Subject: Proposed 2-lot subdivision of SBL 95.4-3-13.210 (99 Peach Lane)

Subject: Response to public comment and letter by Ms. Maria Stavroulakis residing at 73 Peach Lane

2-LOT SUBDIVISION FOR:
NASON
S.B.L.: 95.4-3-13.210 / 99 PEACH LANE / 23.38 ACRES
TOWN OF MARLBOROUGH, ULSTER COUNTY, NY

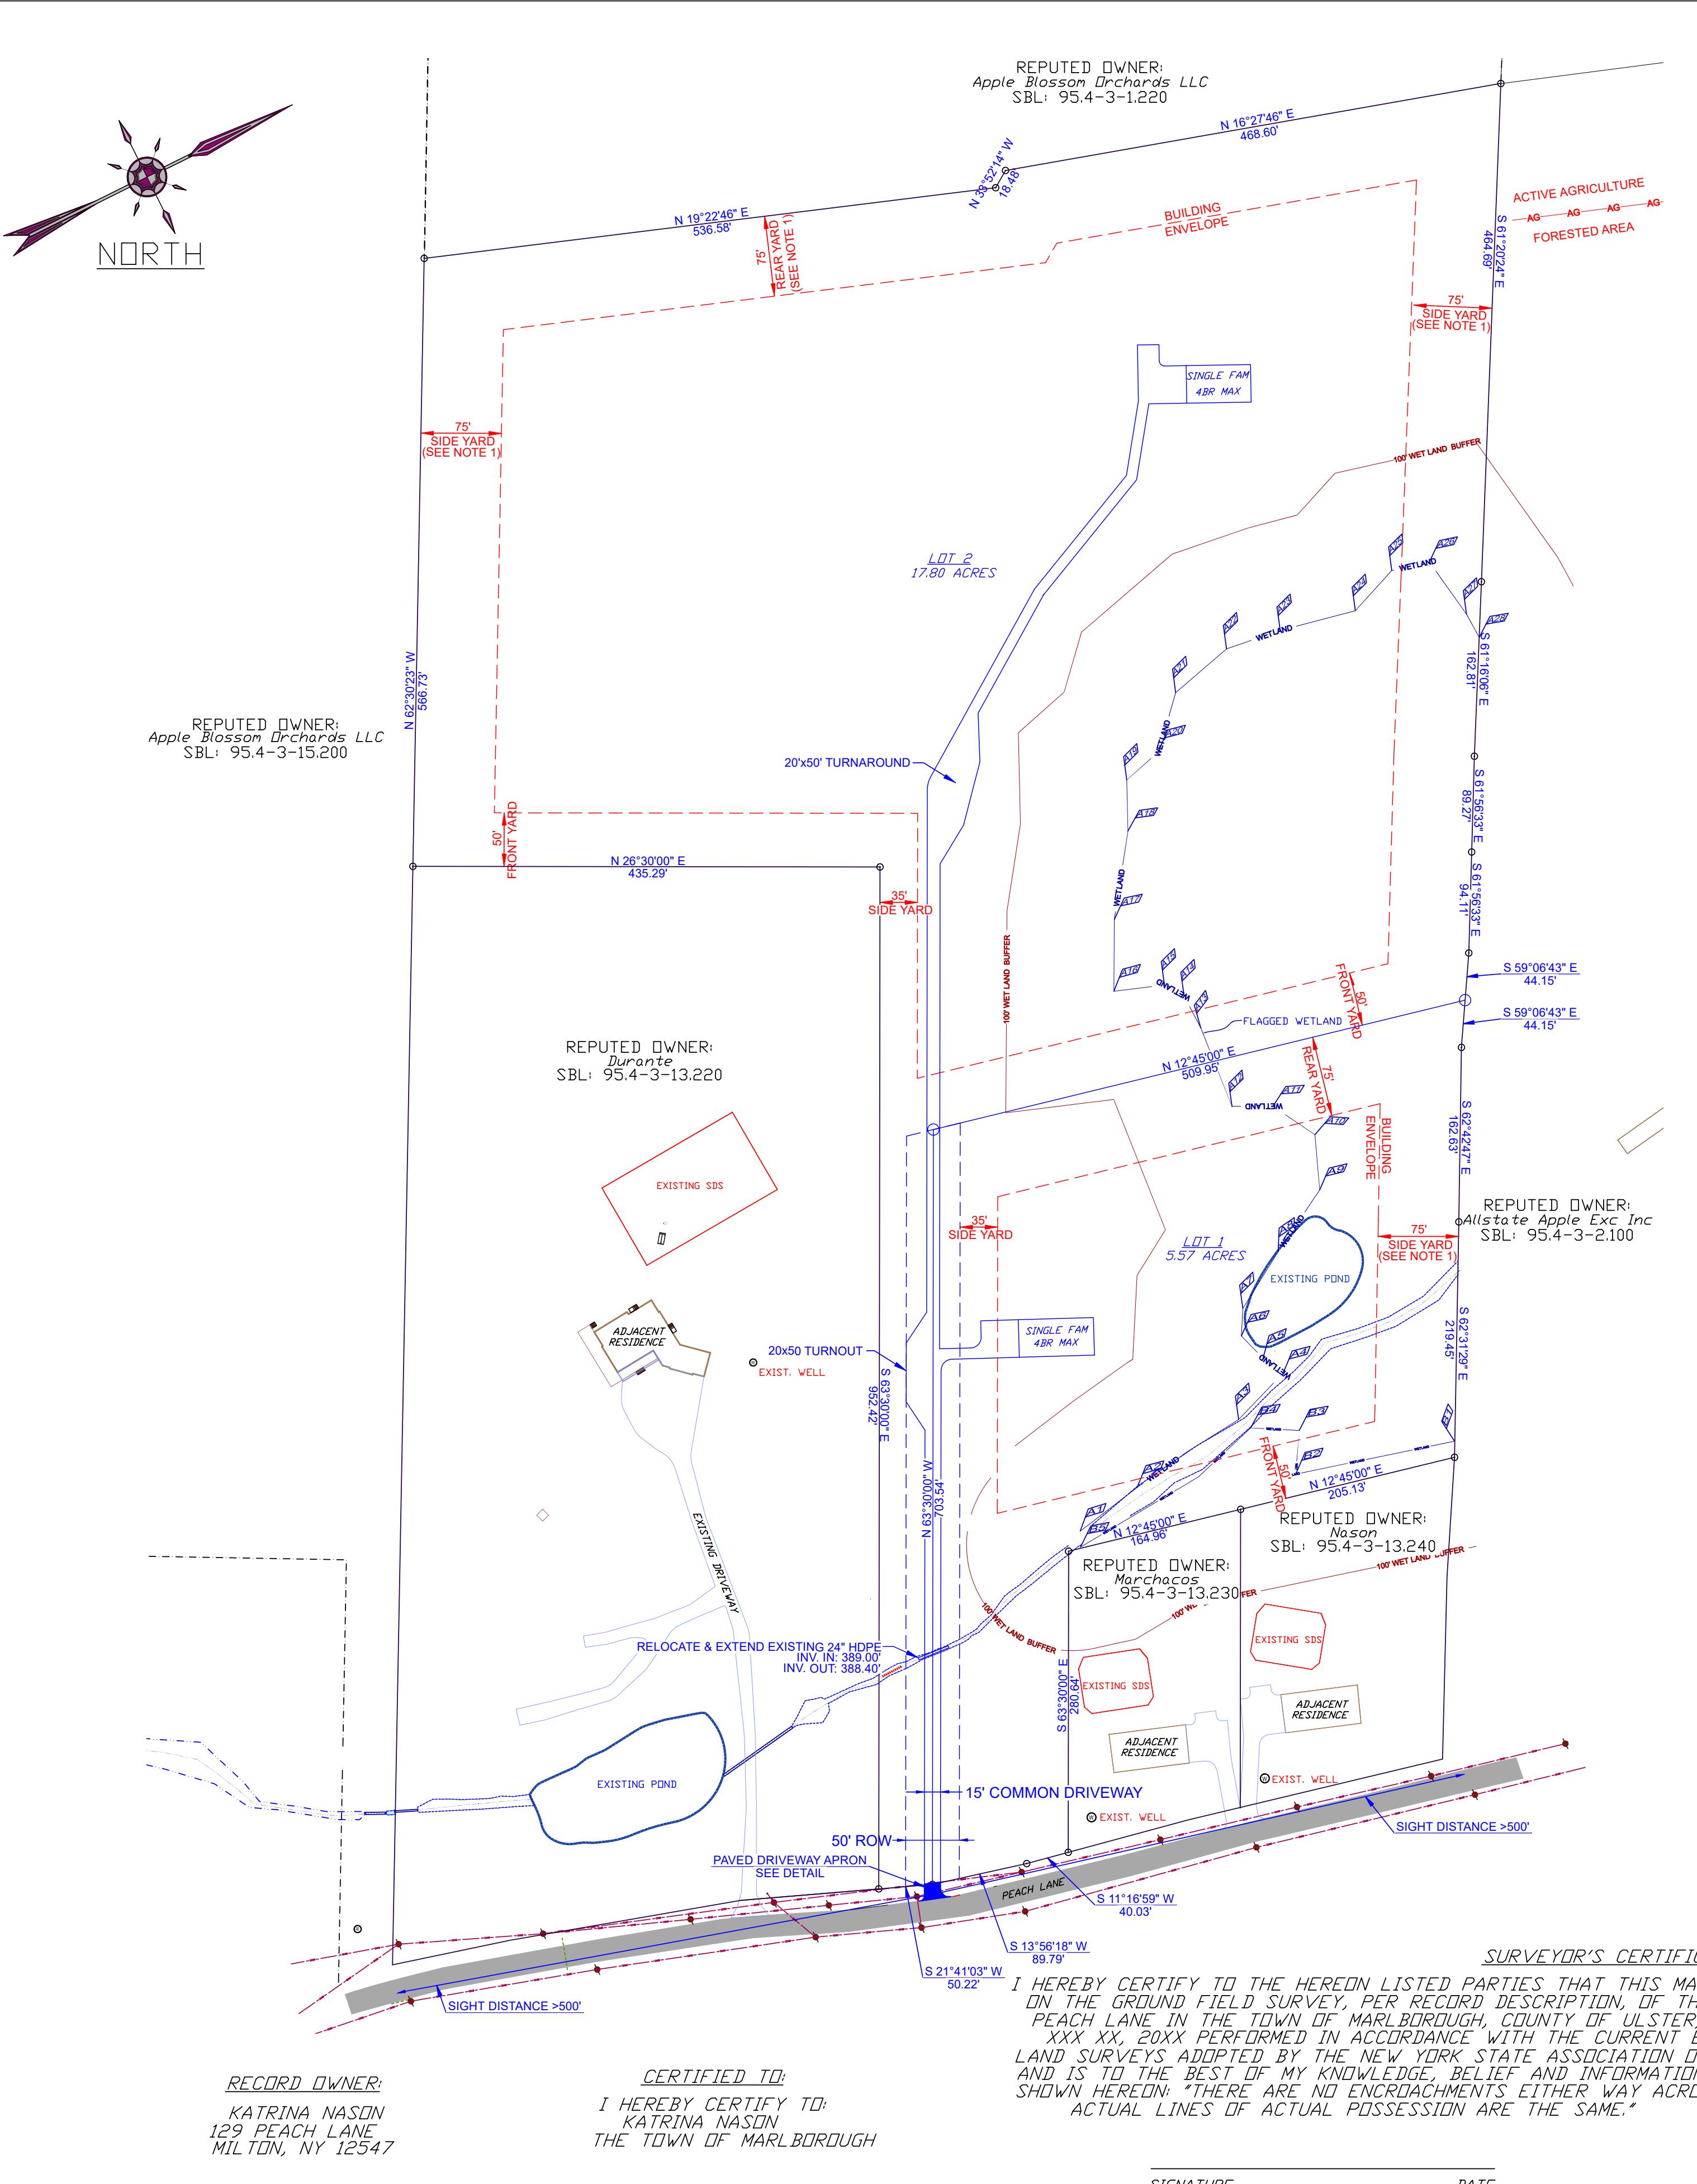
I am in receipt of a flooding concern brought to light by Ms. Stavroulakis at 73 Peach lane.

I have evaluated the area of concern and have concluded that the drainage issue experienced on her property is likely due to an existing undersized pipe as she suggests or an existing pipe grade opposite the natural flow of the watercourse.

In either case, the pipes are situated on the parcel at 89 Peach lane and were present prior to Ms. Nason's 4-lot subdivision approved in 2021. Only one pipe (the 20lf 24" pipe under the driveway of Lot 1) was installed as part of that subdivision and was done so in accordance with the line and grade indicated on subdivision plans.

The problem pipes Ms. Stavroulakis refers to are upstream of the proposed Nason 2-lot subdivision at 99 Peach lane currently before the planning board.
